# **MYO FINAL MONITORING REPORT**

# LAUREL SPRINGS STREAM AND WETLAND MITIGATION SITE

DMS Project No. 100122
Full Delivery Contract No. 7890
DMS RFP No. 16-007725 (issued 11/13/18)
USACE Action ID No. SAW-2019-00835
DWR Project No. 2019-0865

### Response to IRT Comments - MY 0, Baseline Report

**Table F. As-Built Planted Species and Stems**

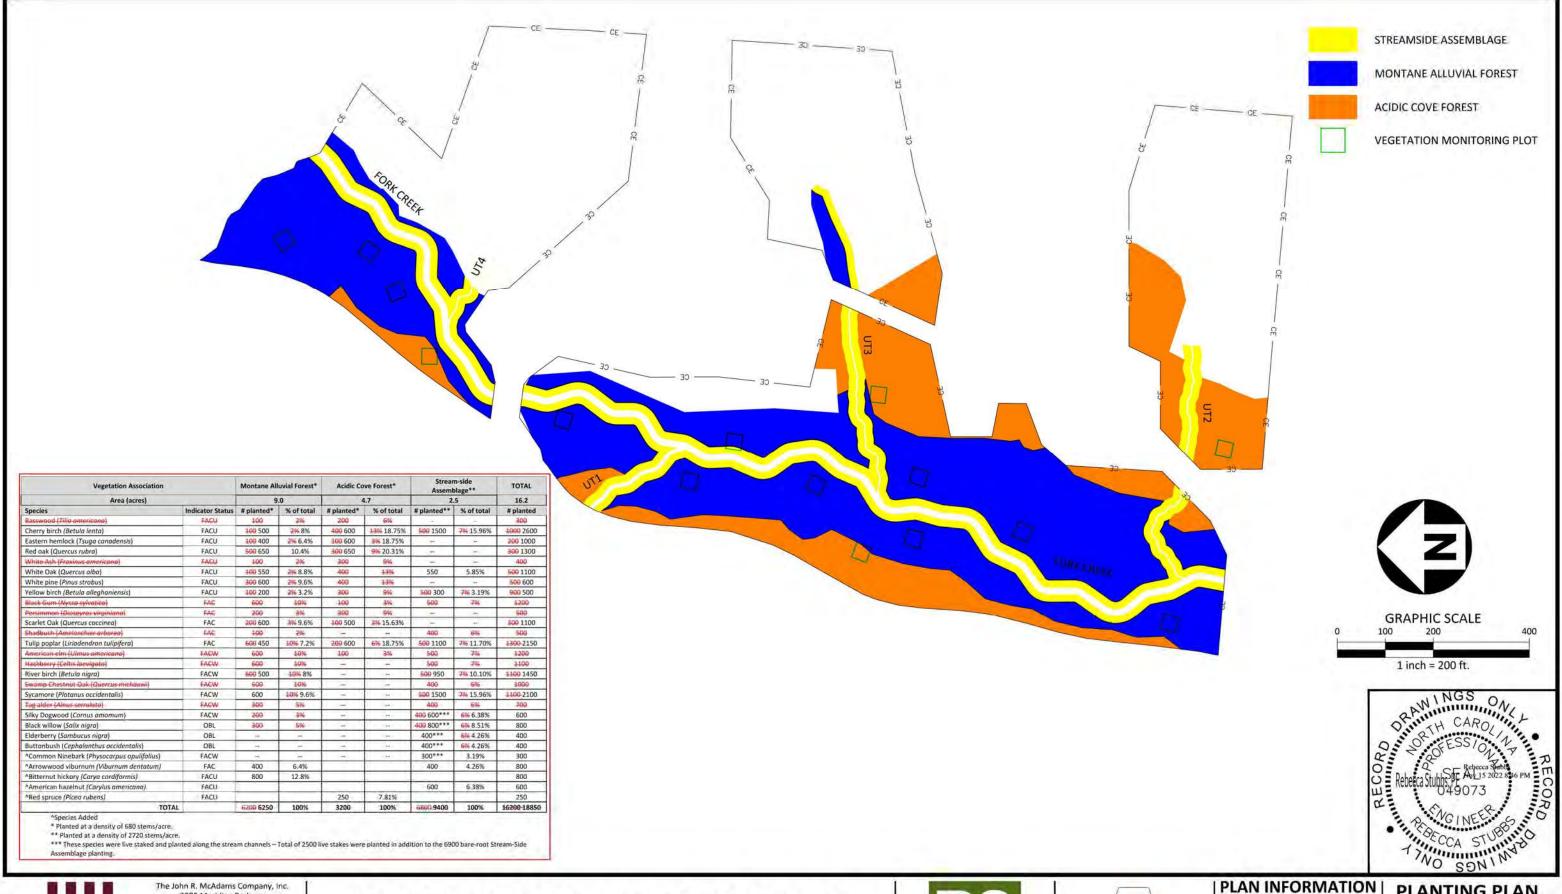
- a. Table A lists yellow birch (Betula alleghaniensis) as a species that was not planted; however, Table B shows it was planted but had it listed as swamp birch (Betula alleghaniensis). Plan Sheet L5 also indicates it was planted. Please clarify.

- c. Sheet L5 lists Scarlet Oak as an added species, however this is shown in Table B (and Table 18 in the Mitigation Plan) as an approved species. Table B lists Red Spruce as an added species, whereas Sheet L5 has it listed as an approved species. Please update.

4. Sheet L5.00: Recommend breaking down each species component (stem counts) into each vegetation community.

- Response: Betula alleghaniensis was planted. The use of two different common names for Betula alleghaniensis (yellow birch and swamp birch) resulted in it being listed in Table A as a non-planted species. The row containing this species was deleted from Table A, and the common name listed in Table B was updated to yellow birch.

- Response: Scarlett oak was planted and was included in the original mitigation plan planting plan; however, the species was incorrectly listed in the mitigation plan as Quercus imbricaria. This has been corrected in the redline Recording Drawings planting plan (Sheet L5) and is not considered a species substitution. Red spruce was not included in the mitigation plan. The redline Recording Drawings planting plan (Sheet L5) and Table F (As-Built Planted Species and Stems) of the Baseline Report were updated accordingly.

Response: The revised redline planting table has broken down species stem counts by vegetation community.

Table 8. Vegetation Plot Data Table from Vegetation Data Entry Tool Planted Acreage 16.2 Date of Initial Plant
Date(s) of Supplemental Plant(s)
Date(s) Mowing
Date of Current Survey 2022-01-12 2022-02-01 Plot size (ACRES) 0.0247

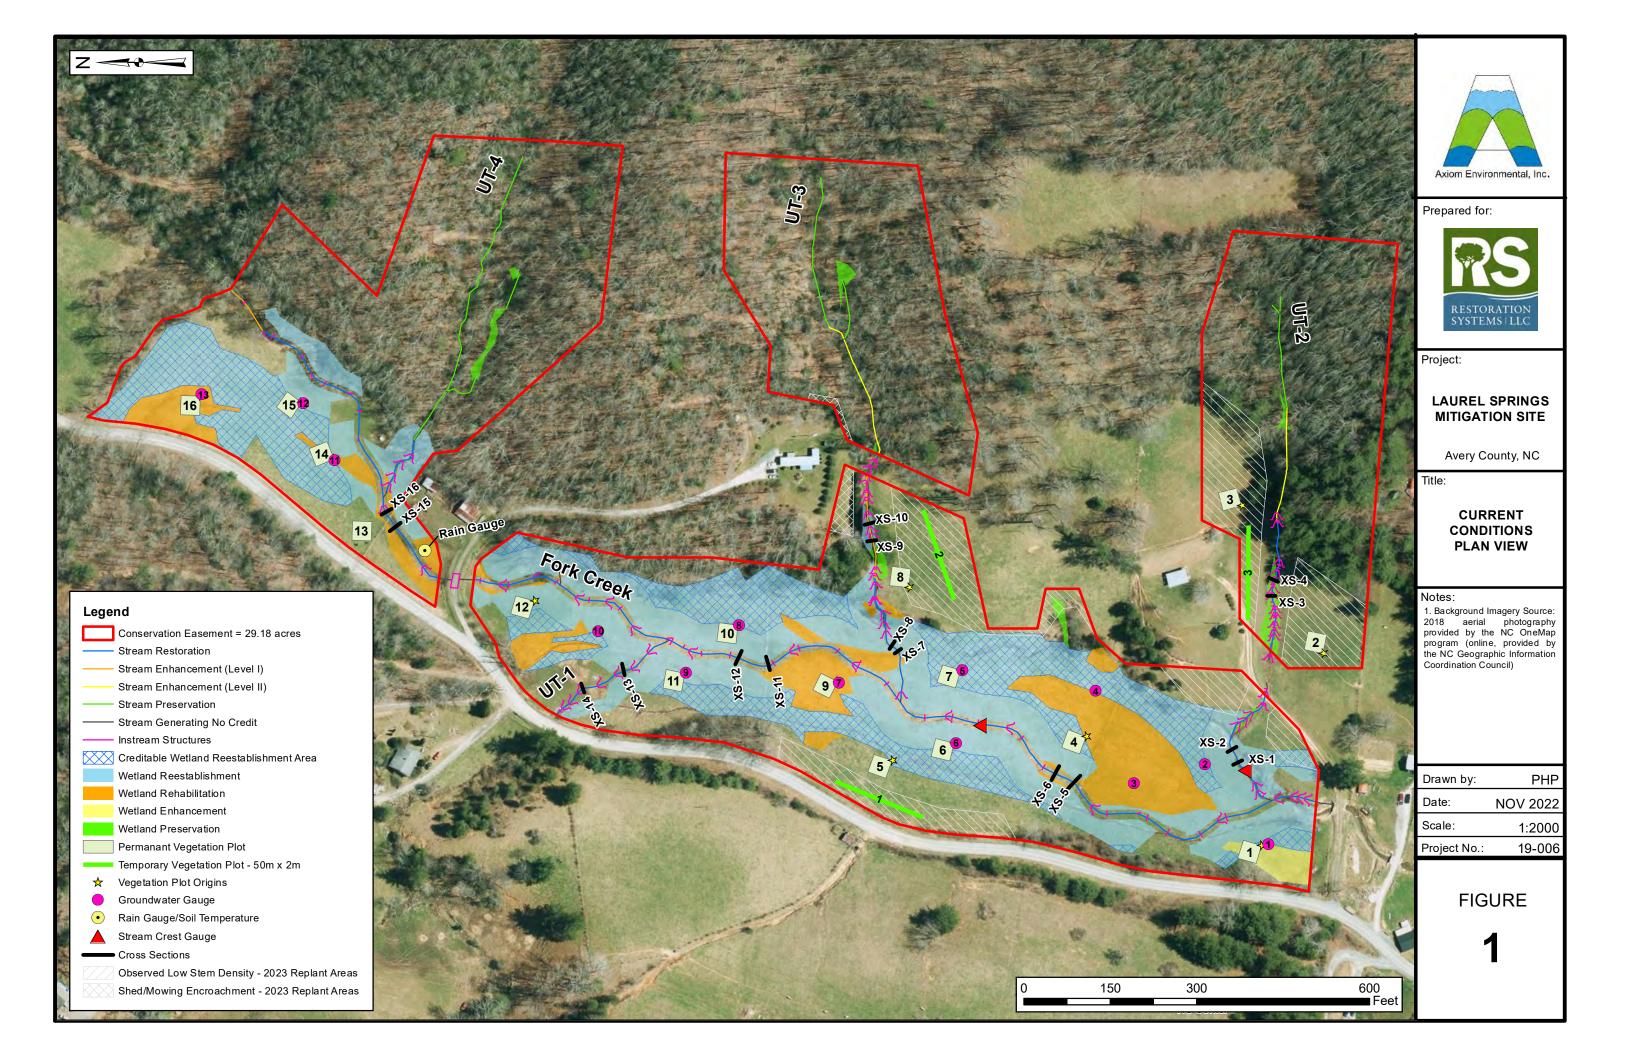
- 1. Table 8: Post Mitigation Plan dominant species composition needs to be recalculated for all plots. Response: Post Mitigation Plan dominant species composition was recalculated.
- 2. Were there no random vegetation plots installed? If not, I recommend adding 3 random plots in place of fixed plots for future vegetation monitoring.

- 10. DWR recommends conducting random plots/transects in proposed supplemental planting areas, with at least one survey area within the UT3 decommissioned farm road footprint.

Response: 3 random vegetation plots will be measured annually in addition to the 16 permanent plots.

- Response: 3 temporary vegetation plots were measured within the supplemental planting areas as part of our response to these comments. Data is included in Table 8 of this submittal. RS plans to monitor 3 random

Attachment - Remedial Planting Plan Figure

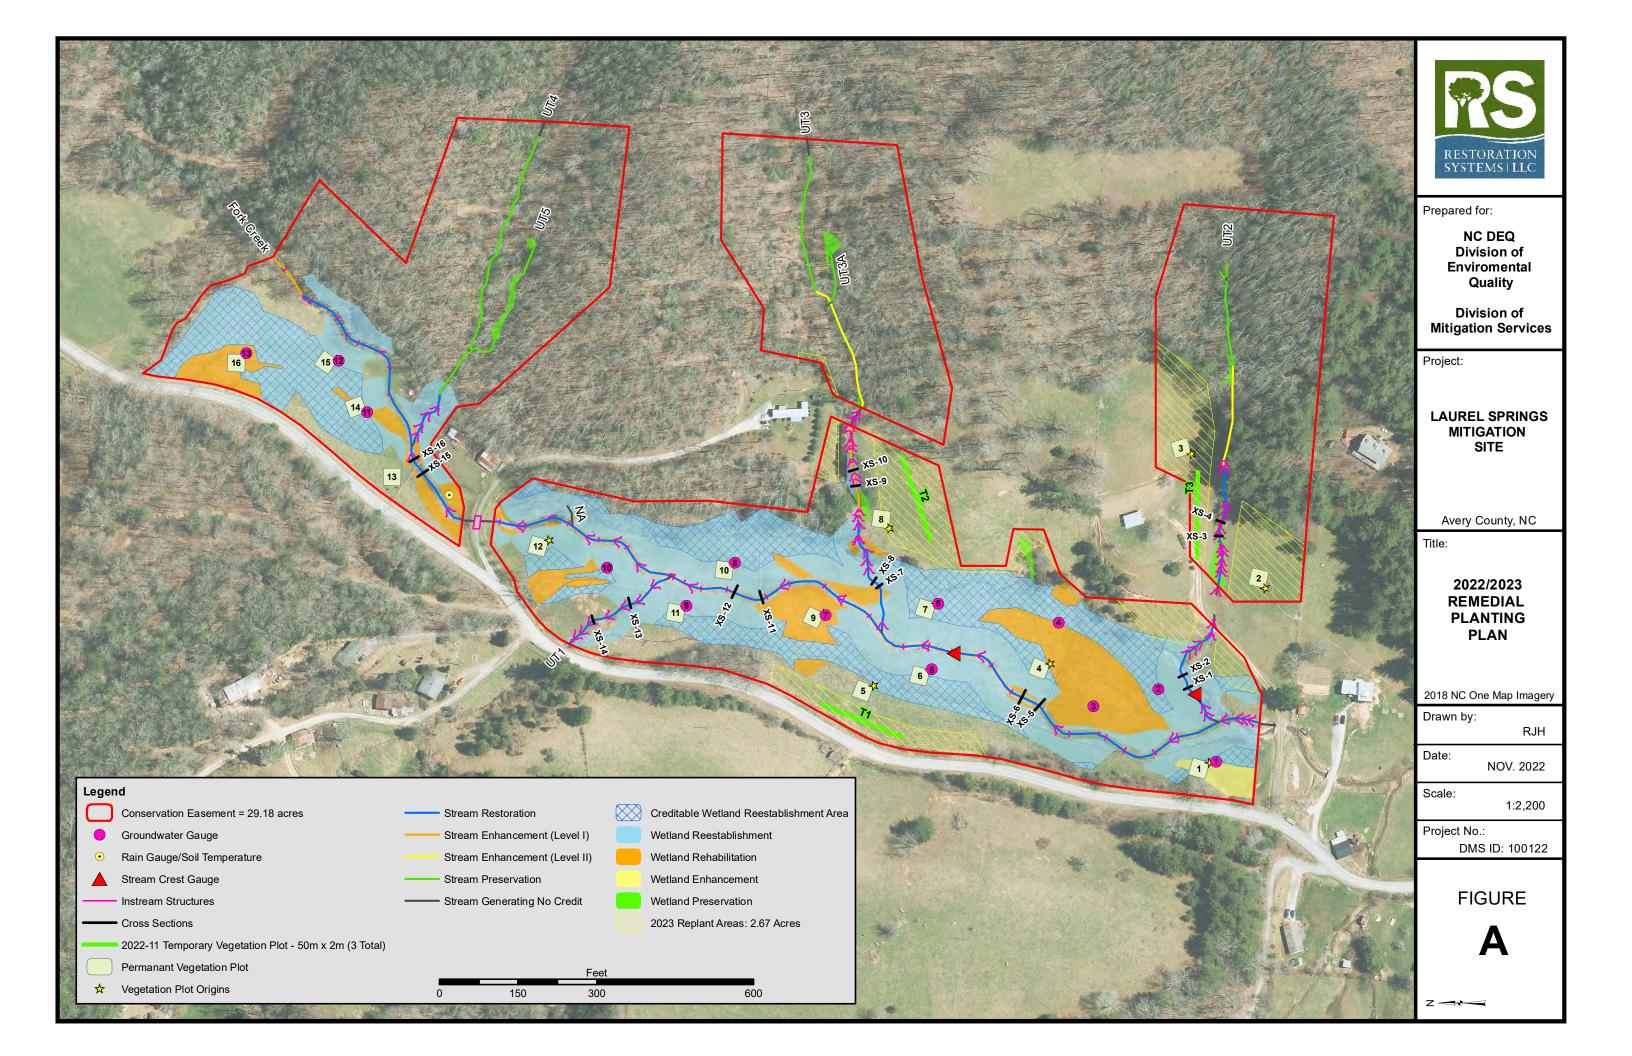
1. The as-built and final mitigation plan do not match when it comes to planting. The numbers/percentages of what was planned (in black) to plant are not what is in the final plan. The planned percentages are also different from the as-built (e.g., hemlock at 2-3% in final plan, but in the as-built as planned at 8% and actually planted at 6%). The MYO report does note that a number of species were not planted (but it is inaccurate, as it fails to include a number of those that were in the final plan and includes Betula alleganiensis, which was planted). Please include me in a discussion with RS; I'd like to have input on the supplemental planting.

During the 2022 growing season, Restoration Systems (RS) has observed areas of low stem densities at the Laurel Springs Mitigation Site (Site). Observed areas total 2.67 acres, which includes a 0.107-acre area of encroachment – see attached remedial planting figure. The encroachment area was partially due to a storage shed left within the easement used by the adjacent landowner. RS worked with the neighbor to remove the shed and cleared the area of all debris. Additionally, 6-inch treated fence posts were used to delineate the easement boundary in this area. A new shed was erected approximately 15 feet from the easement.

RS has ordered trees to replant the 2.67 acres at a density of 670 stems per acre. The replant areas are within the Acidic Cove Forest Association. The following species and quantities were secured for Q1-2023 planting.

These species were listed within the approved mitigation plan but not planted within the Acidic Cove vegetation association during initial planting. These three species will add to the six species planted during initial planting for nine total species within the Acidic Cove vegetation association.

Figure 1. Current Conditions Plan View
Table 4A-E. Visual Stream Morphology Stability Assessment Table
Table 5. Vegetation Condition Assessment Table
Vegetation Plot Photographs
Photo Log

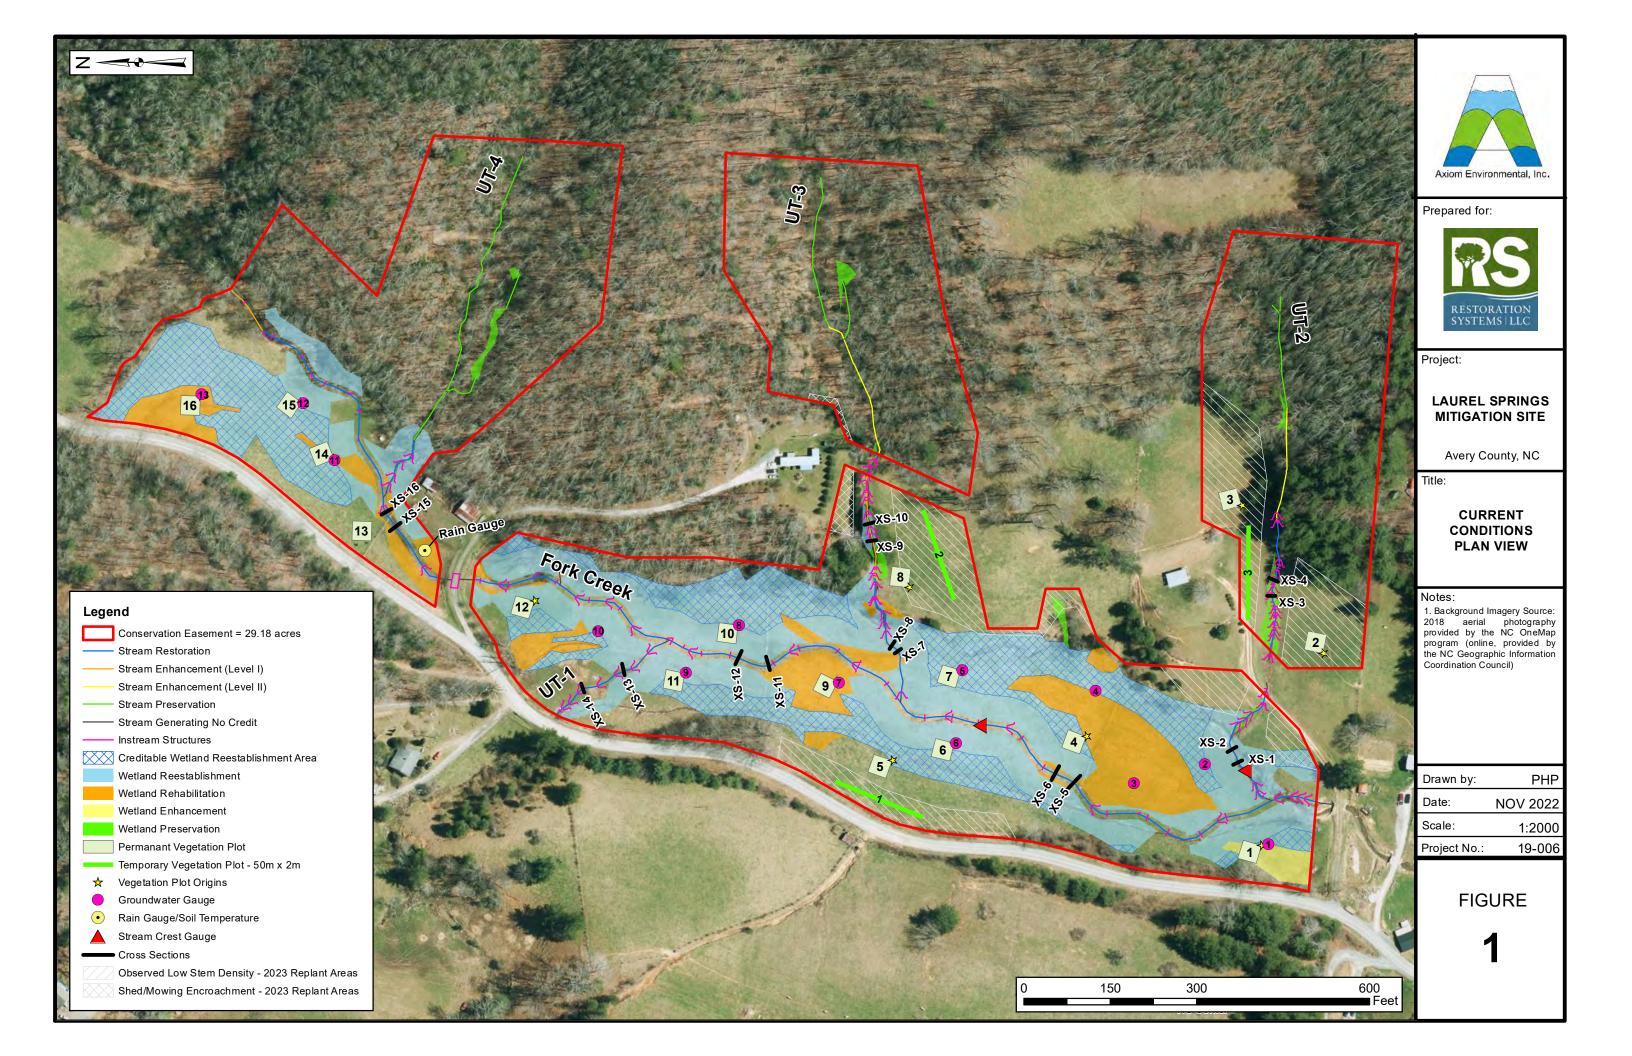
- 3. When comparing the MYO CCPV (Figure 1) to the updated Monitoring Map (Figure 9) provided on August 26, 2021, some of the veg plots and groundwater gauge locations appear to be flipped and are no longer located in creditable wetland reestablishment areas (GWG 1, 6, & 9). While it's beneficial to have some groundwater gauges located in non-credited wetlands, please ensure creditable wetland reestablishment areas have adequate monitoring wells to document hydrologic uplift.

8. Section 4 – Monitoring Year 0 – Data Assessment: The hydrology assessment section references 16 groundwater gauges; however, Figure 1 shows 13 ground water gauges. Please review this section and update as necessary. Please also document any significant monitoring device location changes from the IRT approved mitigation plan (if any).

Response: During the 2022/2023 dormant season, RS plans to move gauges 6, 9, 11, and 12 into creditable wetland reestablishment areas. Also, gauge 1 will be moved into the wetland enhancement area, as depicted in Figure 9 of the approved Mitigation Plan. Please advise if the IRT would like additional changes to the locations of monitoring features.
- 4. Appreciate the efforts made to work with the landowner to remove the shed located in the easement near UT3. To help prevent future encroachments (such as mowing), were additional boundary markers or horse tape added to this area when the surveyor visited the site on 9/2022? When the new shed is constructed, please be sure to have the structure located far enough off the easement boundary to prevent any future encroachments.

Response: Understood. During the 2022/2023 dormant season, RS plans to move gauges 6, 9, 11, and 12 into creditable wetland reestablishment areas. Also, gauge 1 will be moved into the wetland enhancement area, as depicted in Figure 9 of the approved mitigation plan. Please advise if the IRT would like additional changes to the locations of monitoring features.
